Attention Martin Schneider From Juan M Mejia
 To AMBASSADOR CONSTRUCTION CO. INC. Job Name OEM
 Address 317 Madison Avenue Job No 5576A
 New York, New York 10017 Phone 212 922-1020 Fax 212 949-9762
 Copy: Joe Allotta / SHCA Date 10/7/98 Time 6:36:41 PM Page 2
 Quantity

Re: FSK-29 ADDITIONAL SLEEVES REQUESTED FOR CABLING.

NEW SLEEVE LOCATIONS @ 23RD FL.

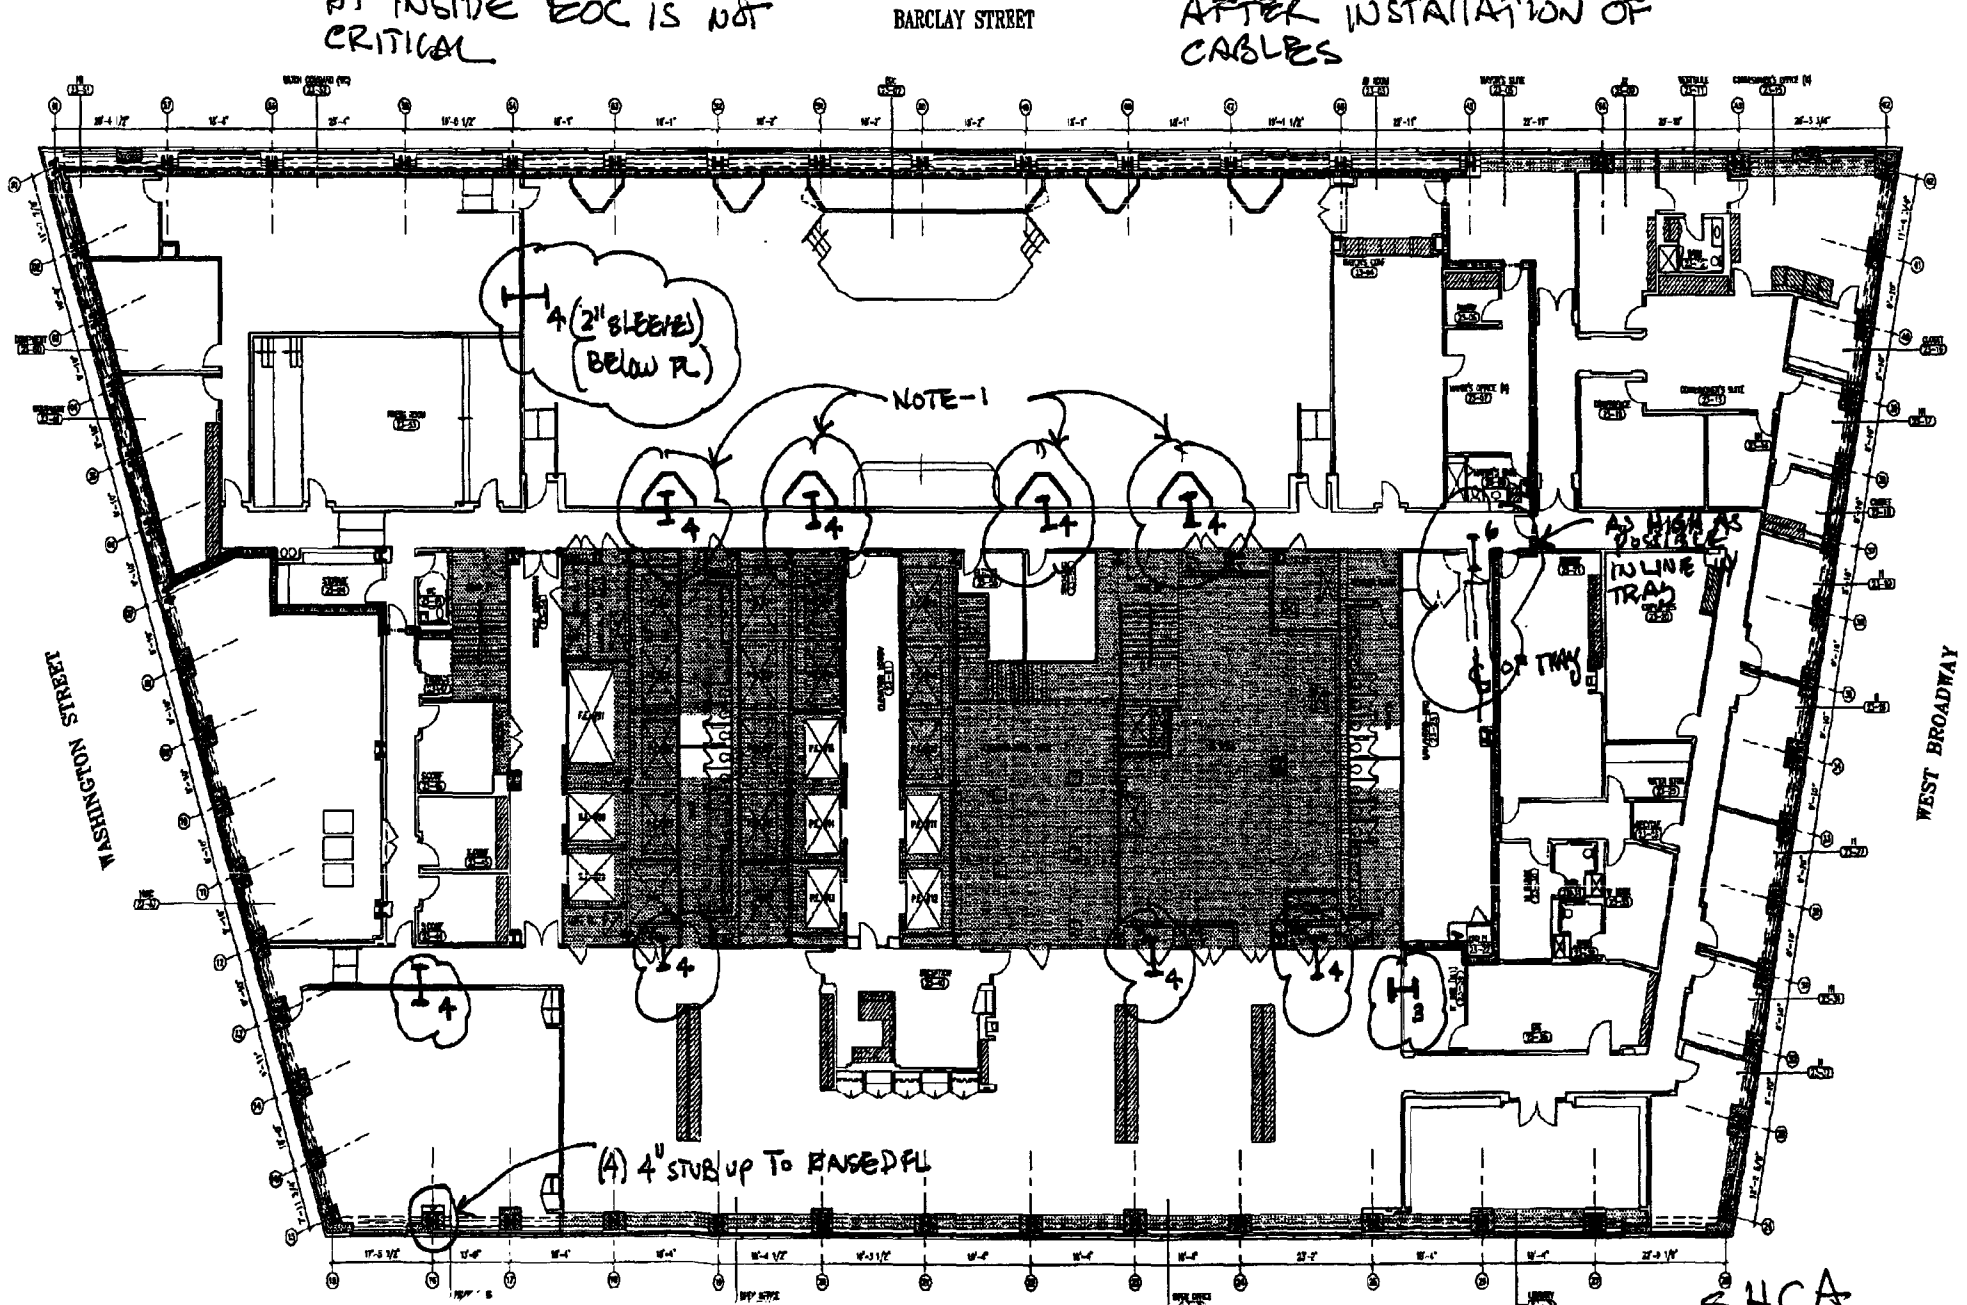
4" INDICATED
 4" ϕ SLEEVE LENGTH AS REQ.
 FOR EASY ACCESS. U.O.N

1- SLEEVES @ EOC SHOULD BE
 LOCATED ABOVE CORR CLG.
 BT INSIDE EOC IS NOT
 CRITICAL

2- GC TO FIRE STOP ALL
 SLEEVES @ CORE WALL
 AFTER INSTALLATION OF
 CABLES
